pd-trigger — Design Document

ai-ee v1 pipeline

Board review (P8 adversarial) - pd-trigger

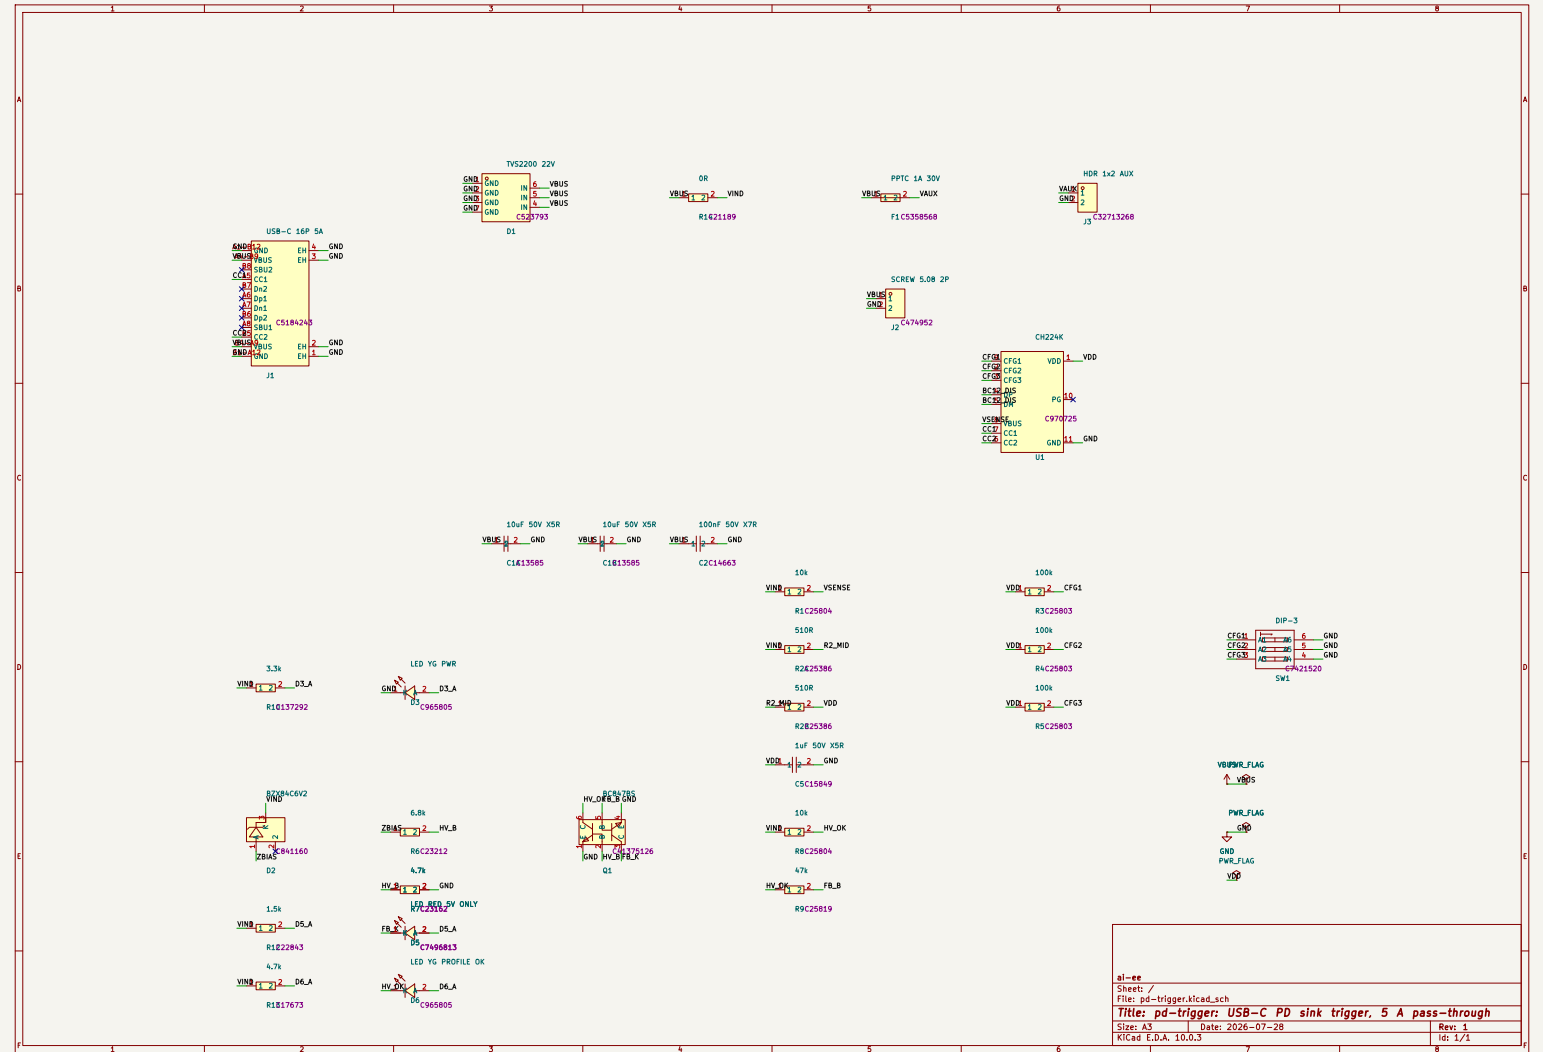
W1 dp-dm-short-at-chip: architecture’s PD-only short (`/BC12_DIS`) ACCEPTED by the reviewer as hardware-SAFER than the datasheet’s connector wiring (removes a 21V-onto-3.8V-abs-max fault path). Cost: no QC/BC legacy support - the board is “PD sources only”; goes on B.SilkS + order docs. W2 vdd-worst-corner: true worst case 0.979mA at 4.4V low-line all-straps- closed vs unpublished CH224K IDD - bounded by WCH’s own reference circuit; V1 bring-up step: measure VDD at the 5V profile; contingency = both 510R -> smaller (documented floor 600R total). Bring-up addenda: buzz out Q1 E/B/C once (clone PDF JS-gated; Nexperia- standard pinning verified as the compatibility claim).

reports/render_final/top.png

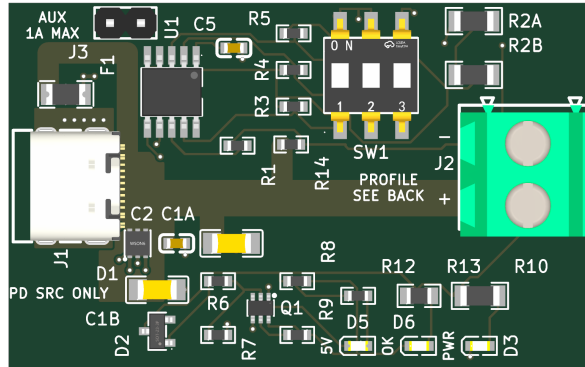
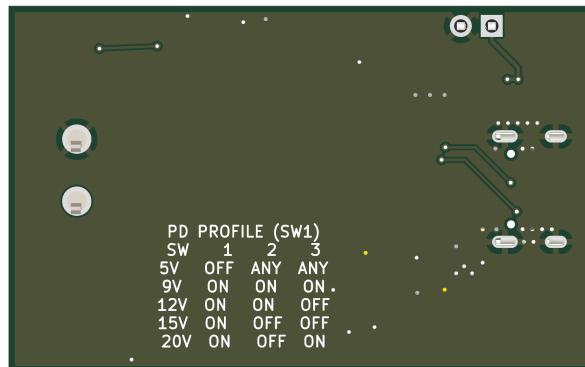
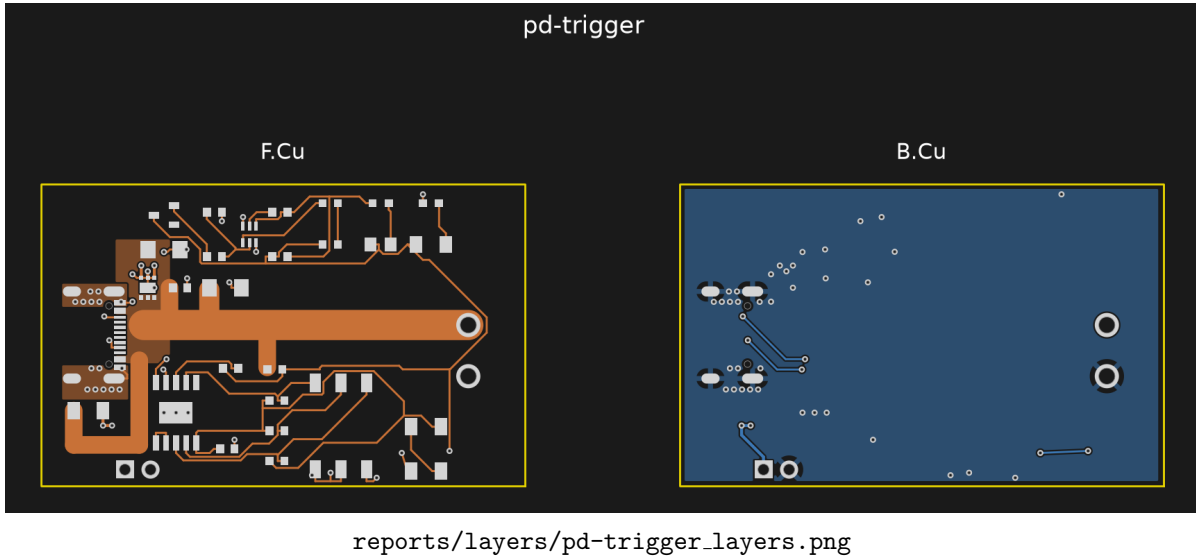
E1 - 5 A return chokes at J1's GND contact pads (error, checker-blind by design D7)

The 4 GND cable contacts land on two merged SMD pads (F.Cu only): A1-B12 at (17.63,39.31) and B1-A12 at (17.63,45.71), nominally 2.5 A each at the 5 A rating. Their ONLY copper into the B.Cu return pour:

- A1-B12 (top): a 0.2 mm wide, 2.7 mm long F.Cu chain (3 segments) into shell pad 1's THT barrel, plus one 0.6/0.3 via whose annulus grazes the pad corner by ~0.05 mm (etch-tolerance-level). 0.2 mm at 2 oz = 0.80 A capacity at 10 C rise (pipeline model); at 2.5 A the same model gives ~133 C rise (short-neck heatsinking will moderate this, but it is a >3x overcurrent on the model's own terms). ~13.6 squares = 3.3 mohm.
- B1-A12 (bottom): a 0.2 mm x 1.3 mm trace into ONE 0.6/0.3 via. The board's own via budget (constraints via_amps 0.5) says 2.5 A needs 5 vias; there is 1. Shell pad 4 sits 0.32 mm away but is NOT connected on F.Cu - its copper does not help.

Architecture D7/power_tree structural requirement ">= 10 vias at J1's GND pads" (the stated substitute for keeping GND out of power[] so check_current stays quiet): not delivered. DRC cannot see it (0.2 mm is netclass-legal), check_current cannot see it (GND undeclared), check_return_path no-ops (no high_speed key). Failure mode: sustained 5 A at any profile heats the two necks far past the 10 C design intent; long-term trace/joint fatigue, intermittent ground, and full return current cascading onto the surviving 0.2 mm chain. Fix is cheap at P9: an F.Cu GND spandrel bonding each contact pad to its shell pad (the VBUS pour top edge is at y 39.7 - the strip above it, and the strip x < 17.2 plus the region south of y 46, are free) plus 4-5 vias per side.

E2 - Safety/waiver silk markings absent (error, promised artifact) Board-wide gr.text count is ZERO; B.SilkS carries nothing at all (both B.SilkS references in the file are the stackup layer table). Missing, each one a written promise:

- AUX 1A MAX + V+/GND at J3 (P0 answer 4 "silk-marked", V10). F1 makes overload safe-by-hardware, but polarity of the 2-pin aux header is unmarked.
- PD SOURCES ONLY (ERC waiver W1's standing condition: "goes on B.SilkS + order docs"). The waiver's silk half is currently unfulfilled.
- J2 screw-terminal polarity. Trunk lands on J2 pad 1 = the LOWER screw (board-bottom side); nothing anywhere tells the bench user which screw is V+. Reverse-wiring a load on a 100 W output is the single easiest field mistake this board can cause.

E3 - User-interface silk absent (error, promised artifact)

- The five-row profile table on B.SilkS - D3 calls silk "the user interface" and specifies the table verbatim; the bottom is a clean pour with room. Without it the ON/OFF-to-voltage map exists only off-board; a user WILL set 9 V expecting 12 V by trial and error. (Fail-safe floor: any wrong guess >= the 5 V fallback, and OFF-fail = 5 V - the mistake is bounded but real.)

- LED legends PWR / 5V ONLY / PROFILE OK (D4/V10): the render shows refdes D3/D5/D6 only. The entire P0-answer-6 "visible fallback indication" scheme is mute without the words - a lit red LED labeled "D5" indicates nothing.

- Cable disclaimer "20V @ 5A needs a 5A e-marked cable and a 100W source" (V10 lists it as silk; power_tree s7 allows documentation - at minimum it must reach the order docs at P9/P10, which do not exist yet; fab/ is empty).

W1 - J1 mouth recessed ~0.4-0.5 mm behind the board edge (warning, flagged at P6) Courtyard/silk front edge $x = 10.18$ vs board edge $x = 9.8$. USB-C receptacles are normally flush-to-overhanging; a recessed mouth lets thick/molded plug overmolds butt the board edge and hold the plug fractionally short of latch - intermittent CC, no PD, "works with some cables". On a bare bench board with arbitrary cables this is a real annoyance risk. Fix: nudge J1 -x 0.5-1.0 mm at P9 (pour edge follows; nothing else in that corridor), or accept and note in order docs.

W2 - Outline 48 x 30 mm exceeds the architecture's hard ceiling (warning, drift) Edge.Cuts = (9.8,27.51)-(57.8,57.51) = 48 x 30 mm. D9: nominal 45 x 25, "hard ceiling 48 x 28 mm"; 30 mm violates D9's own ceiling by 2 mm even though it equals P0 answer 5's literal +20 % (40x25 -> 48x30, +44 % area vs the brief's target). No digest discloses the growth past D9. Consequence is cost/footprint only, but it must be disclosed to the user at the checkpoint rather than discovered.

A1 - J2 GND pad ties to the return pour through 4 thermal spokes (advisory) J2 pad 2 (THT, 2.4 mm pad / 1.6 mm drill) connects via 4 x 0.5 mm diagonal spokes = 2.0 mm total at 2 oz -> model 8 C rise at 5 A. Legal and functional, but these are the most-loaded copper necks on the whole return after E1, at a hand-soldered joint. Recommend a solid-connect override (or a short fat GND strap) at P9; zero cost. (Verified all 4 spokes present; the VBUS pad 1 island below it is barrel-tied, normal.)

A2 - F1's VBUS feed branch is 18.3 mm long (advisory, V8 letter-violation) V8/D8 wanted all five VBUS taps hugging the run with 2-3 mm stubs. D1, C1A, C1B, C2, R14 comply; F1's feed runs 8.4 + 6.5 + 3.4 mm at 1.75 mm width to the top-left corner. Width-compliant (V8's actual purpose), carries ≤ 1 A in service; only cost is ~30 mm² of extra always-live 20 V copper. No action needed; recorded as drift.

A3 - Floating 0.65 mm² GND sliver at (20.0, 28.5) (advisory, cleanup) plane_repair's own dead-island fact (0 anchors), between J3/SW1 clearances. Cosmetic / minor DFM nit; remove at P9 cleanup or accept.

A4 - /VAUX at PPTC max-non-trip current (advisory) /VAUX routes at 0.3 mm (required 0.25 at the declared 1.0 A -> 7 C). F1's worst sustained NON-trip current is ~1.8 A -> model 27 C rise on those runs until/unless the PPTC trips. Bounded, no damage threshold approached (70-80 C copper on a 20 V node); acceptable. Recorded so nobody "fixes" it blind later.

```
# P8 digest (pd-trigger)
verify PASS 8/8 first try. Fable reviewer: 4 err + 2 warn. Copper errors
REAL: 5A RETURN choked at J1 GND pads (0.2mm necks/0.80A, 1 via) - rebuilt
w/ priority-1 F.Cu GND lobes (connect.pads solid) + 15 new 0.6/0.3 vias ->
5.68A/4.70A per pad, 16 vias (D7 >=10 met). Removed 2 stitch vias 0.121mm
from THT drills - LIVE-PROVEN KiCad DRC blind spot (via-drill vs same-net
pad-drill never checked, finding 34). Silk errors: 17 texts added; agent
CORRECTED the orchestrator's B-table spec (raw CFG bits would be inverted
vs ON=GND switch reality - printed switch positions). Warns: mouth recess
-> order docs; outline 48x30 deviation recorded; C1B channels waived w/
numbers. Re-gates: drc_routed 0/0, verify 8/8. H4 AUTO-approved.
```
